ADDENDUM NO. 2

**YOLO OF DARKE COUNTY, INC.
Greenville Downtown Urban Park
June 14, 2018**

Re: YOLO of Darke County, Inc.
Greenville Downtown Urban Park

SPRAY SECTION

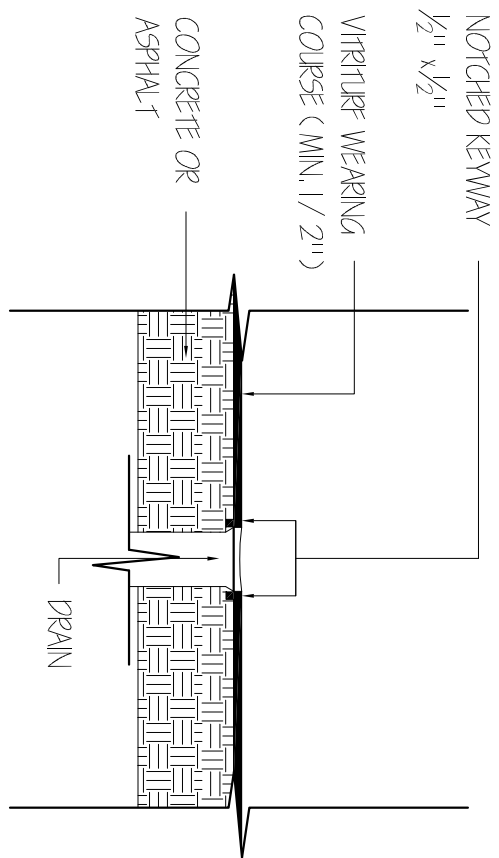
The attached technical specification and Details for nozzles and drain, shall be added to the Contract Documents for use with the surface shown on Sheet 21 of 25. The 9'-4" radius is the area of application for this product. All materials, labor, equipment, and incidentals for the installation per the manufacturer's installation instructions shall be included in the Base Bid.

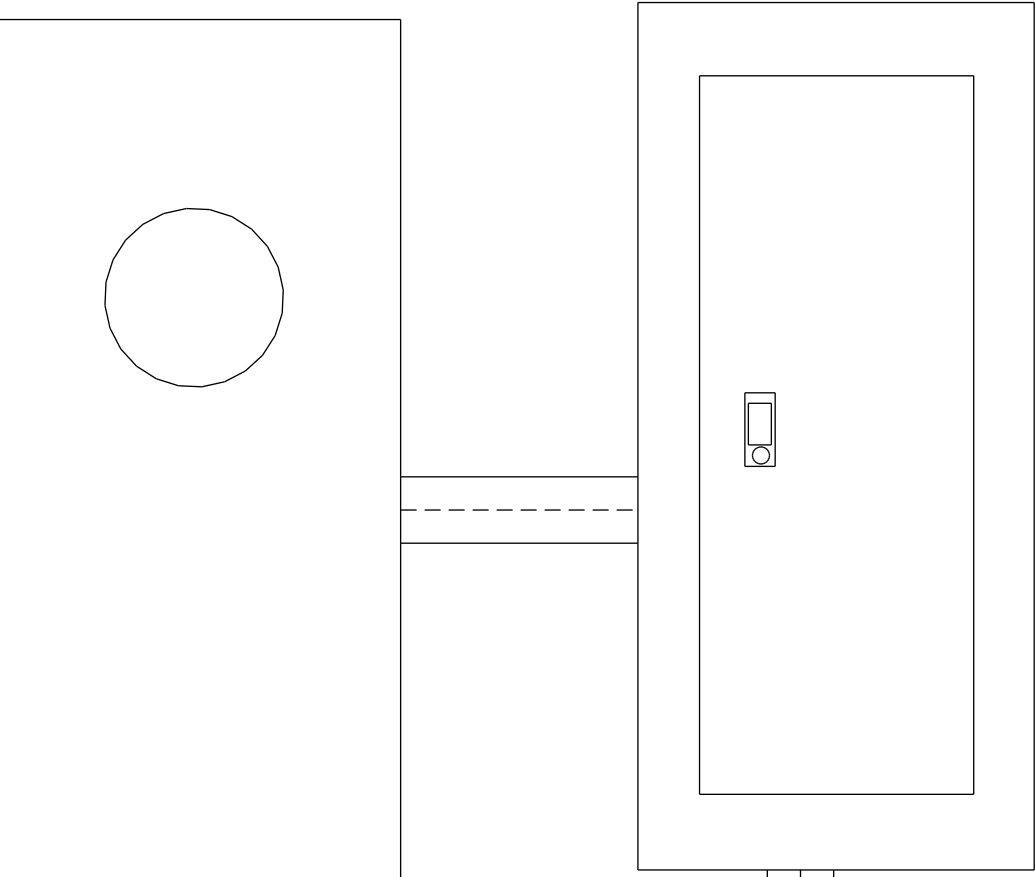
Attached is the electric panel layout to be added to Sheet #23 of 25 (Lighting Plan).

Note: Include Quad outlets
in Open Air Struture
for additional power
for future band events.

Note: 100 amps 240 volt
Single Phase
Main Breaker
Weather Proof Panel Board
20 Circuit Min. Space

Note: All wiring to be in conduit
All work to meet all codes
Provide Photo Cell controller
for all fixtures.
